Checking of the cylinder head assy. 2/3 for ROTAX_® Engine Type 912 and 914 (Series)

This ASB revises ASB-912-062UL/ASB-914-044UL Revision 1

ALERT SERVICE BULLETIN

This ASB revises ASB-912-062/ASB-914-044 Revision 1

Fig. 1 spark plug

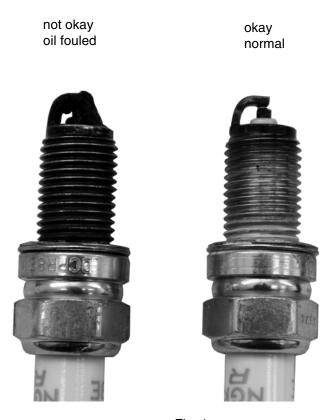
Step	Procedure		
1	Visual check of both spark plugs per cylinder (top and bottom).		
NOTE:		Unusual deposits (excessive carbon or oil) on the spark plugs are an indi- cation of a defective cylinder head which must be replaced. Figure 1 shows comparison between a used spark plug in normal condition and one that is not.	
NC	DTICE	Affected spark plugs with such deposits shown in chapter 4 Fig. 1, have to be removed and can not be reinstalled.

If excessive deposits (oil or carbon) are found on the spark plugs the cylinder head must be replaced in accordance with the relevant Maintenance Manual (Heavy) and any relevant aircraft manufacturer instructions.

At tightening the cylinder head with 2 collar cap nuts M8 and 2 hex. nuts M8 pay attention to the changed tightening torque. Tighten to 10 Nm (90 in.lb) and then in addition tighten further by applying a 120° rotation.
